Addendum: 1
Date: 10/31/2024
Project: **Clinton Central Rooftop Unit Replacement**
Comm #: 24594

The following items shall be incorporated into the specifications and drawings and are considered to be integral to the bid documents for the project. Acknowledgement of receipt of this addendum is required on the bid form.

SHEET
S1.1

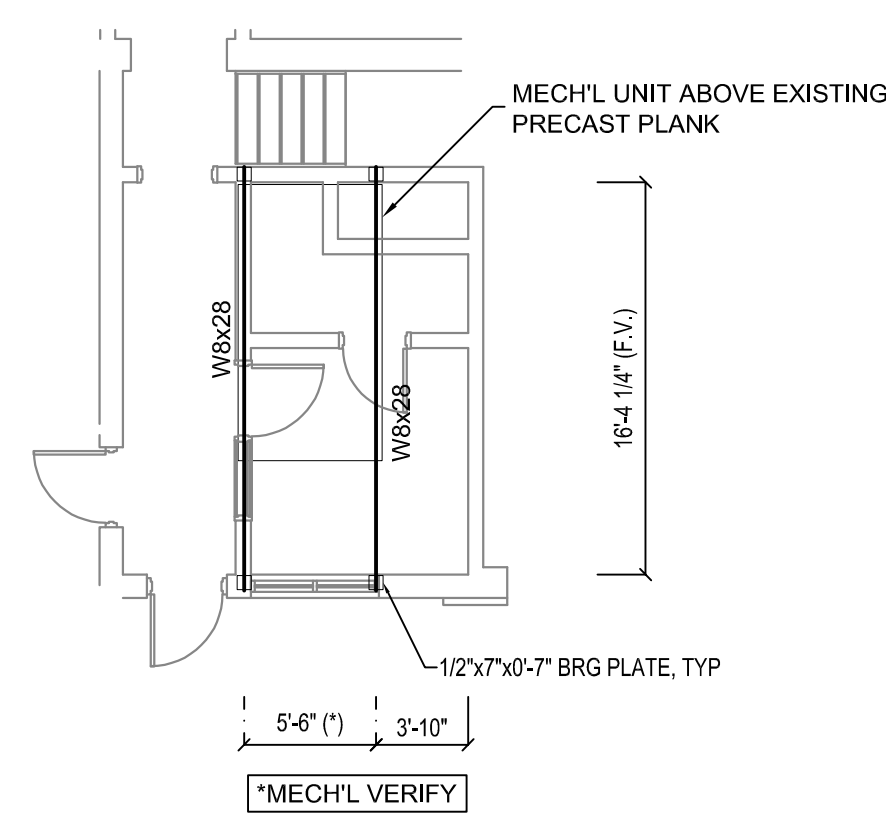
Item #2: Drawing Sheet S1.1, "Structural Framing Plan, Notes, and Details"

- A. See added new sheet for structural reinforcing for AHU-4 at the high school.

HOLD W8x24 TIGHT TO BOTTOM OF EXTG PRECAST PLANK. GROUT OPEN SPACES SOLID WITH NON SHRINK, NON METALLIC GROUT.

Mezzanine Reinforcing Plan
 SCALE: 1/8" = 1'-0"

SHEET:
HS-M201

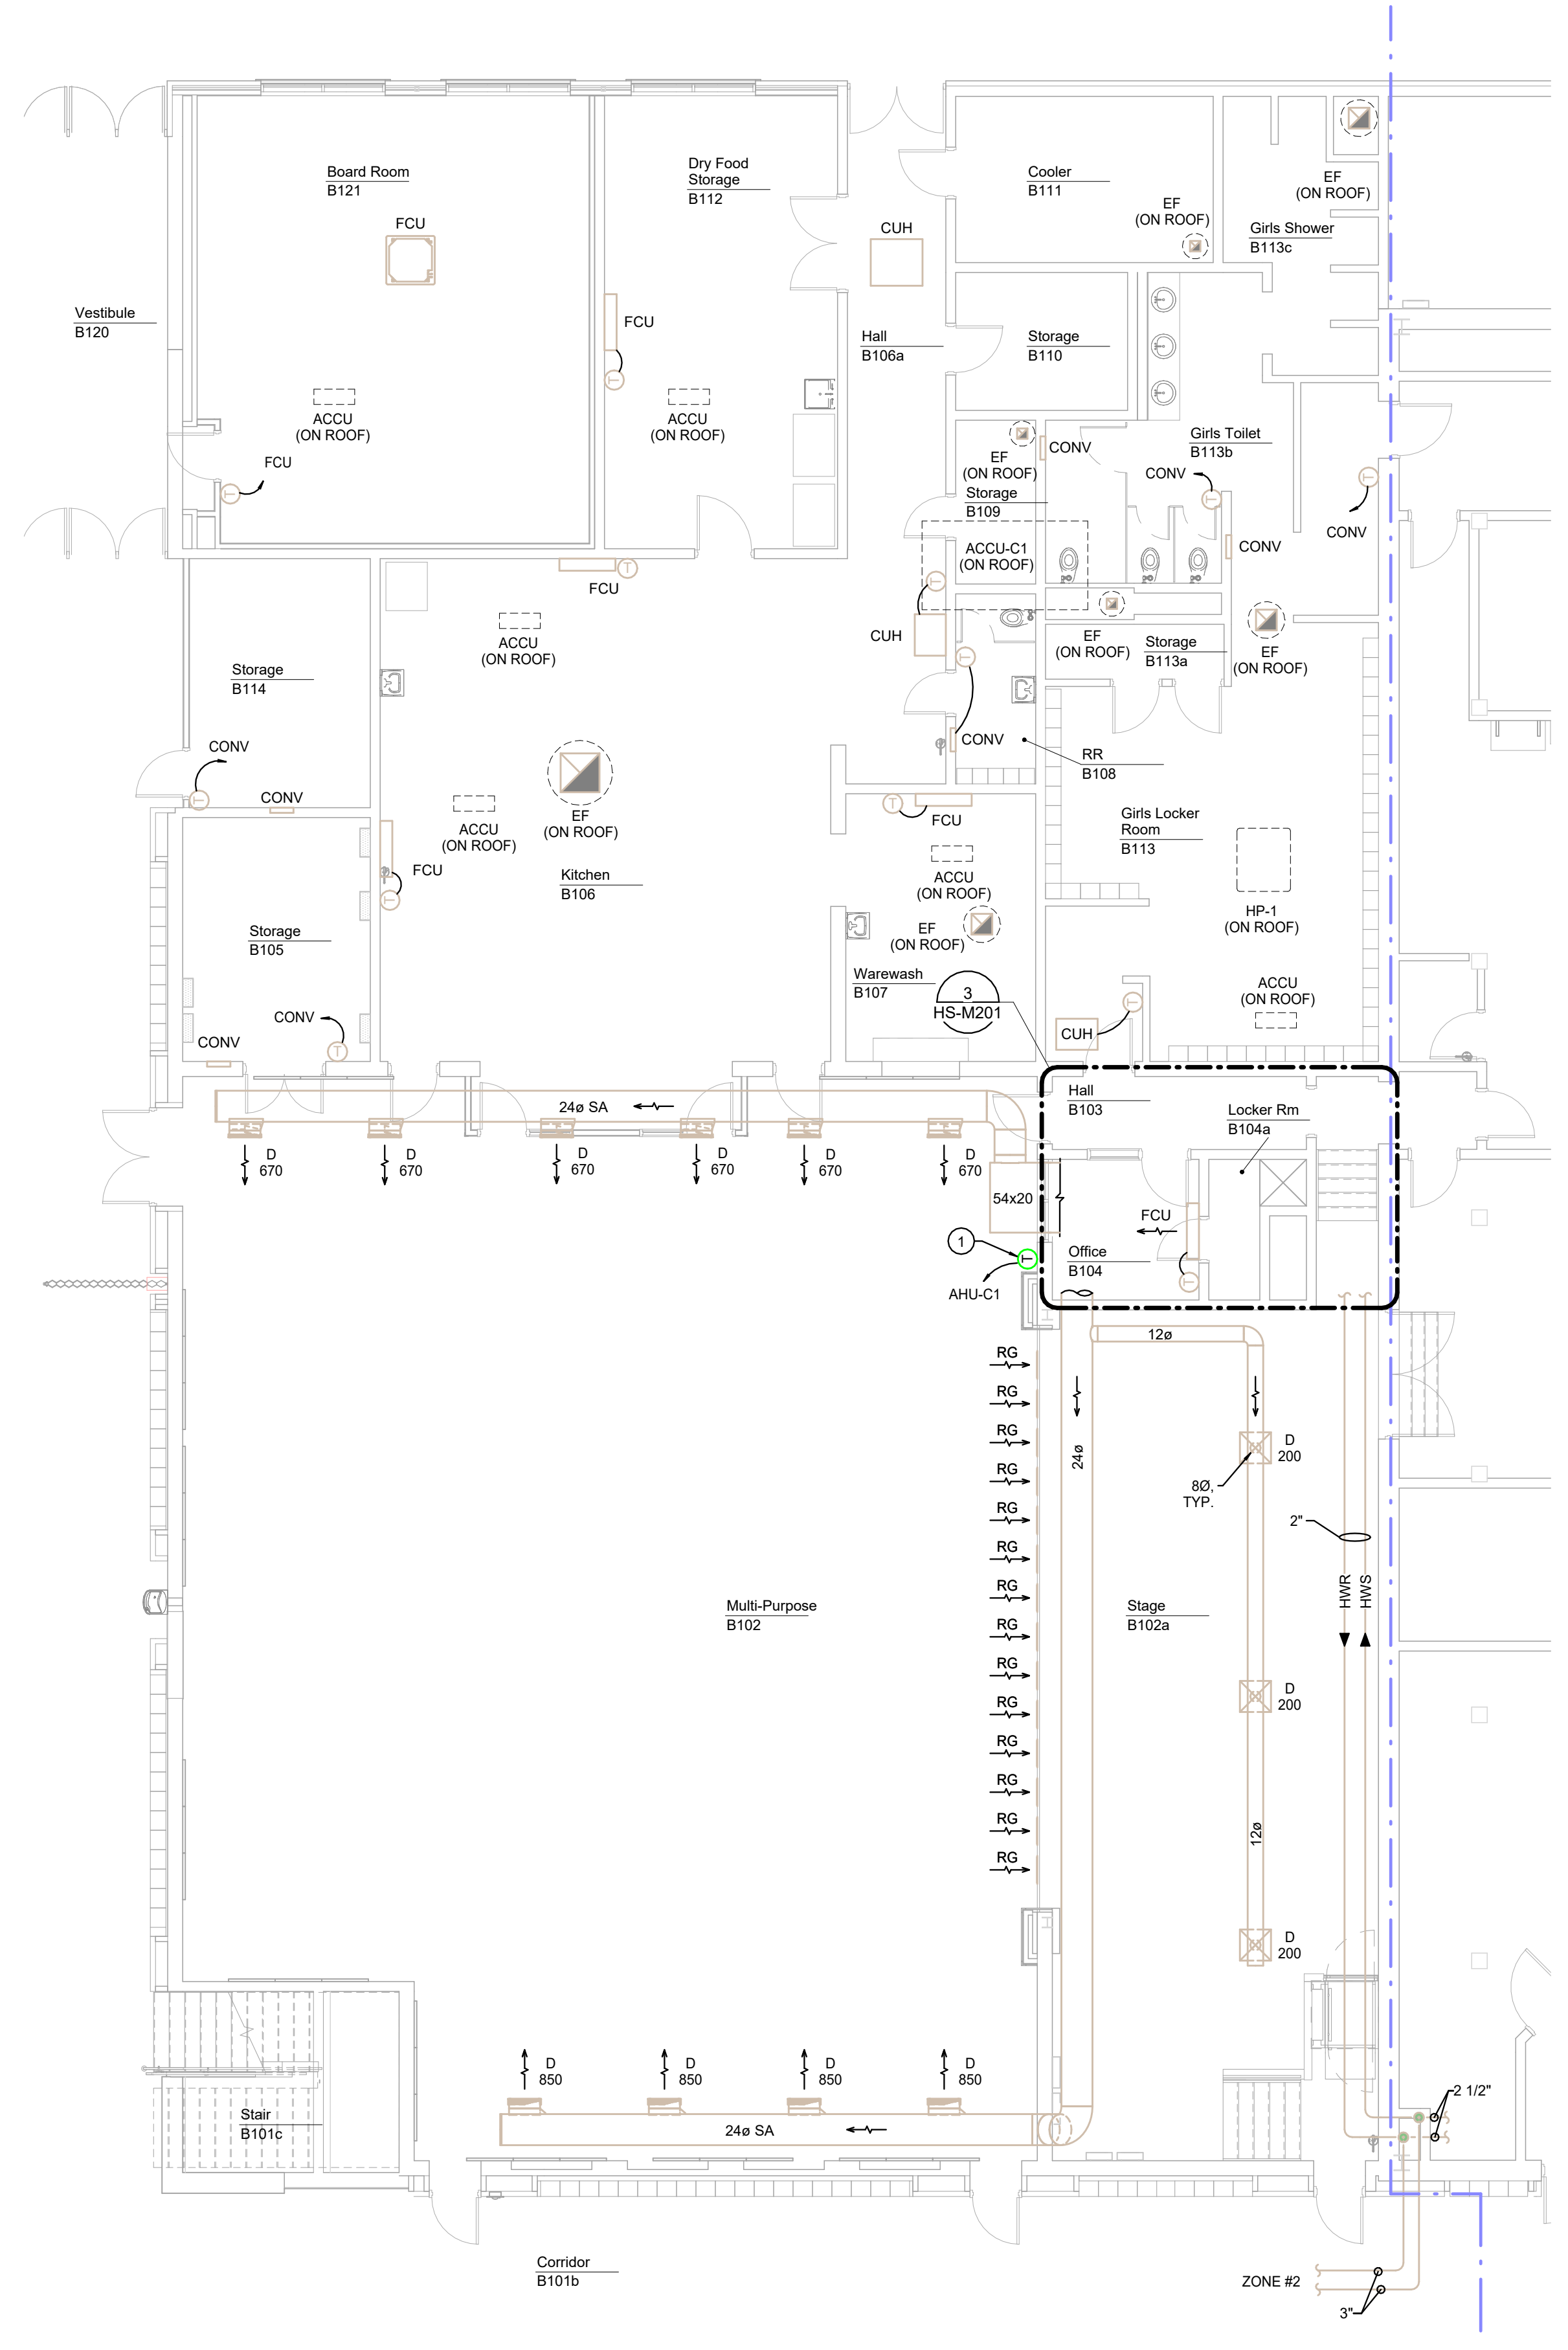
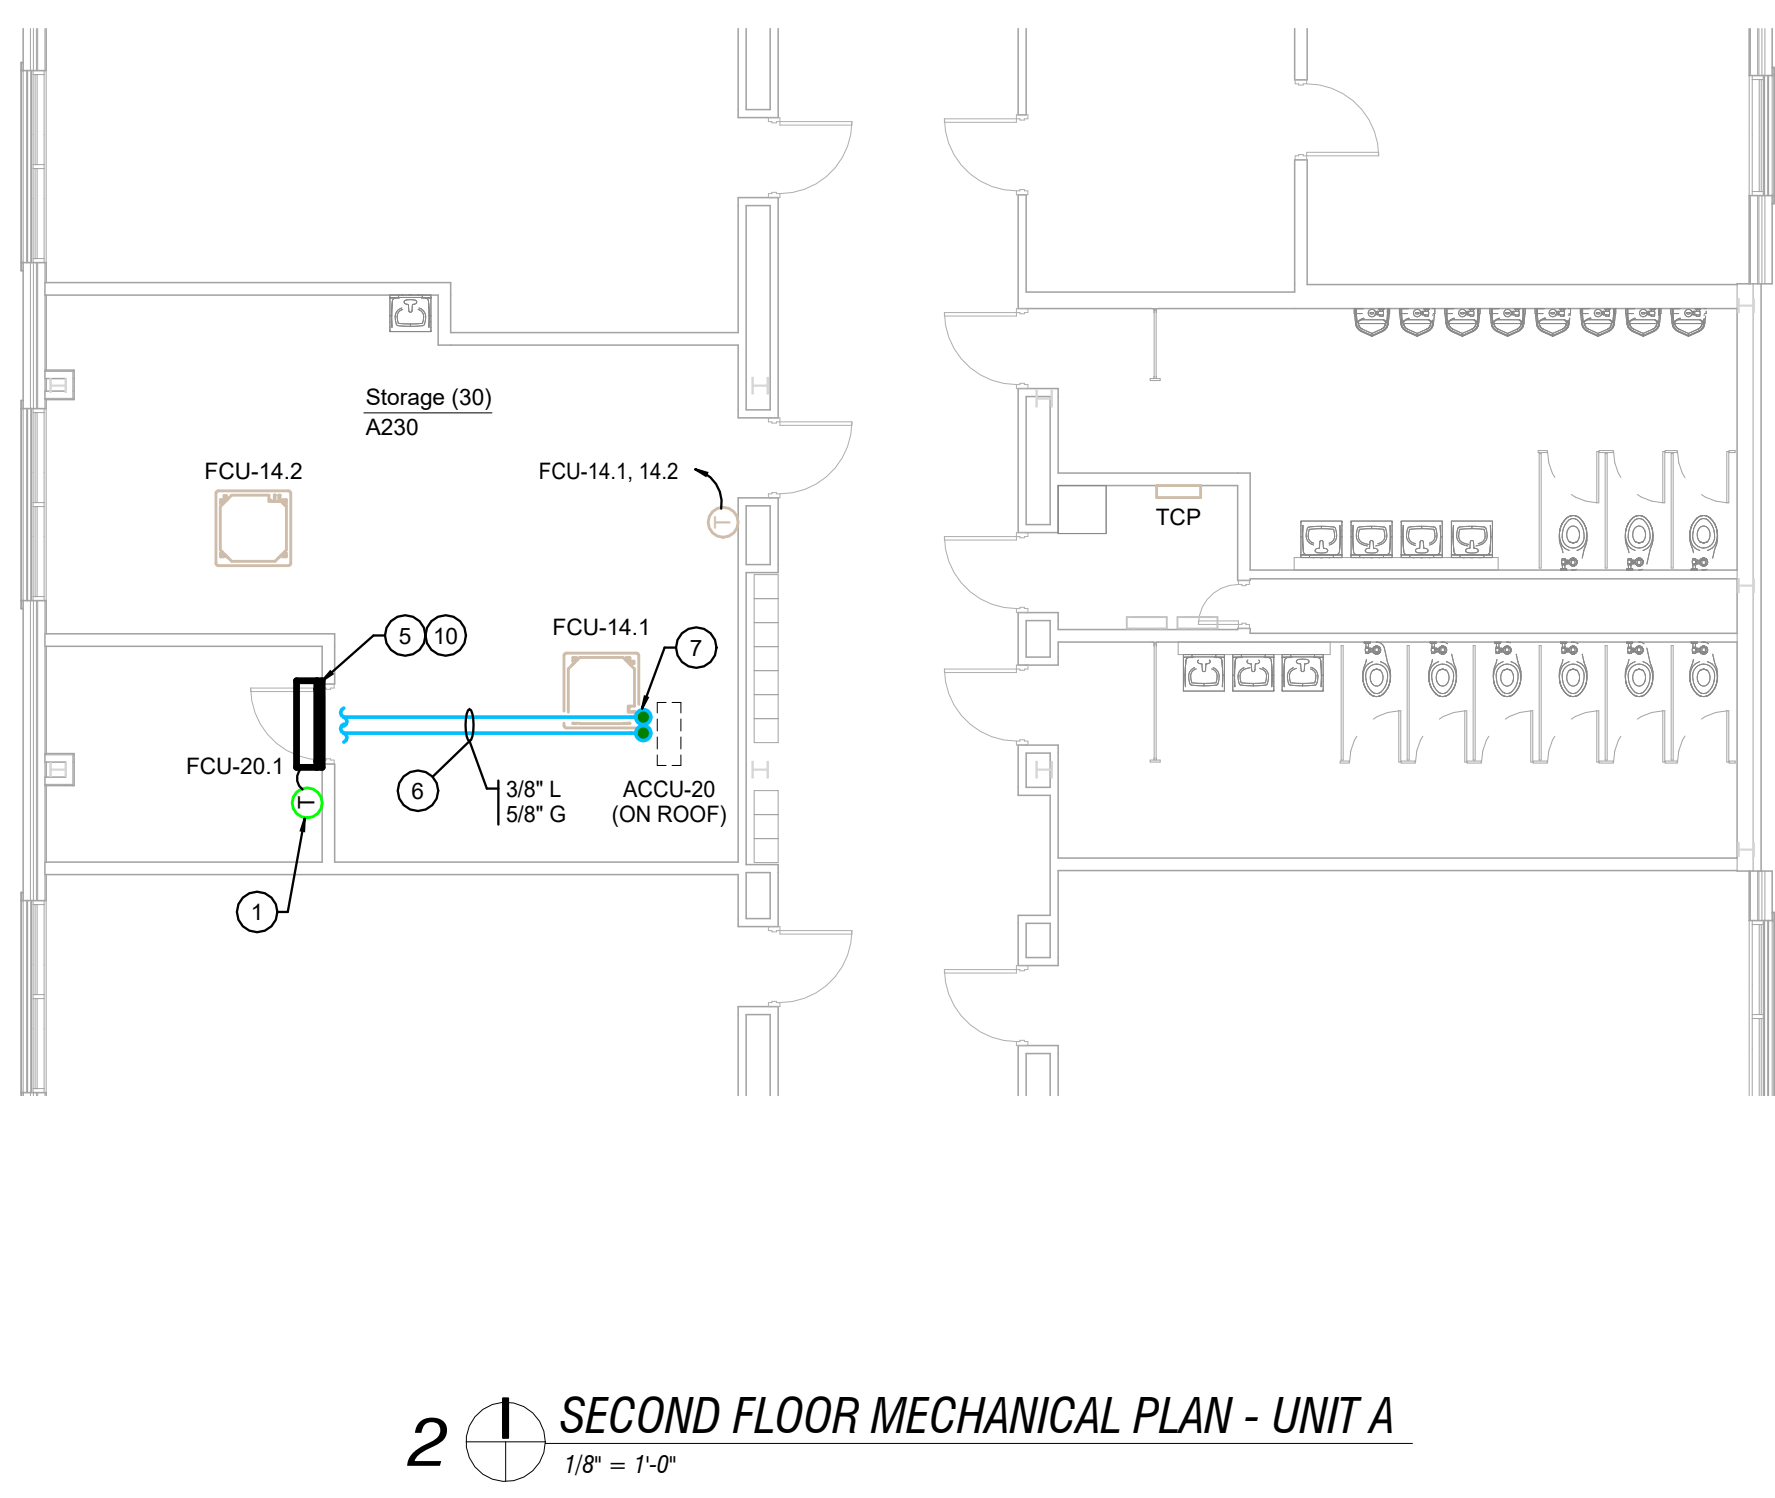
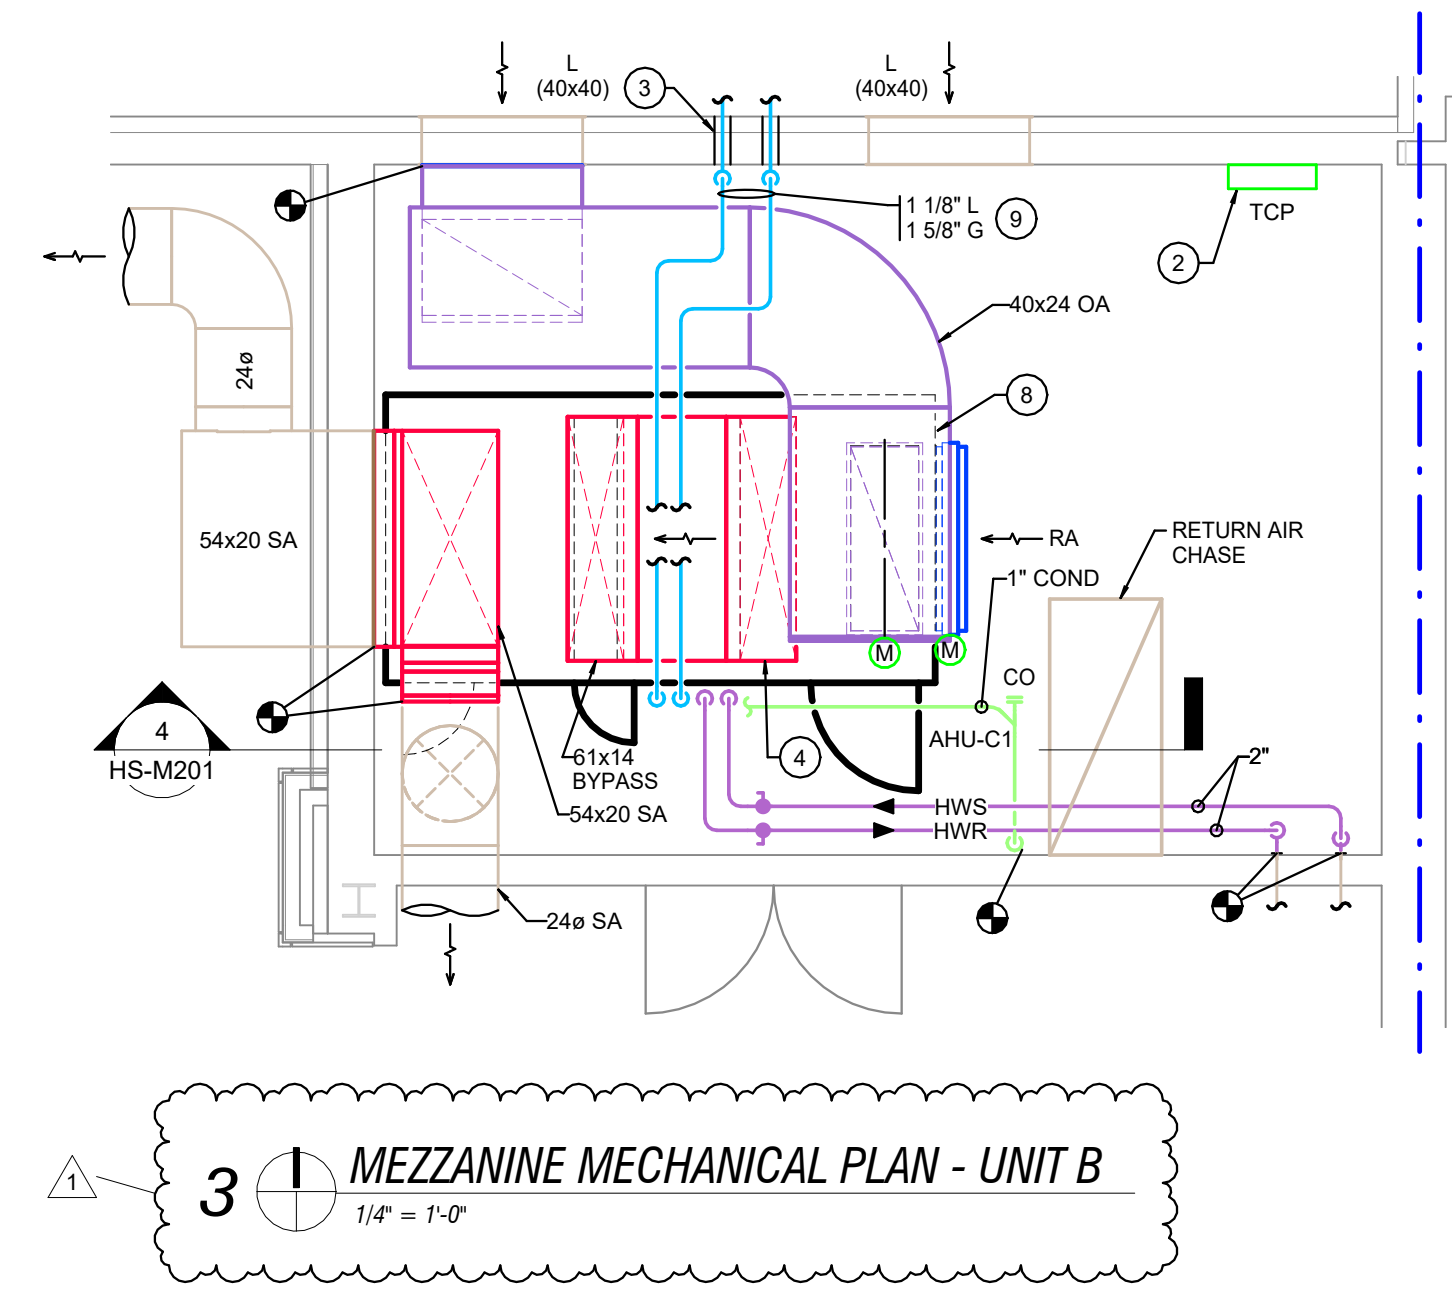
Item #3: Drawing Sheet HS-M201, "Mechanical Plans – Unit A and B"

- A. Revised plan notes and sections to remove the concrete housekeeping pad under AHU-C1. New steel beams will be under the new air handler in lieu of a concrete pad.

8. INSTALL NEW AIR HANDLER ONTO NEW STEEL BEAMS. REFER TO SHEET S1.1 FOR MORE INFORMATION.
 9. REFER TO MANUFACTURER FOR SIZING OF REFRIGERANT PIPING.
 10. TIE INTO EXISTING CONDENSATE PIPING AS REQUIRED.
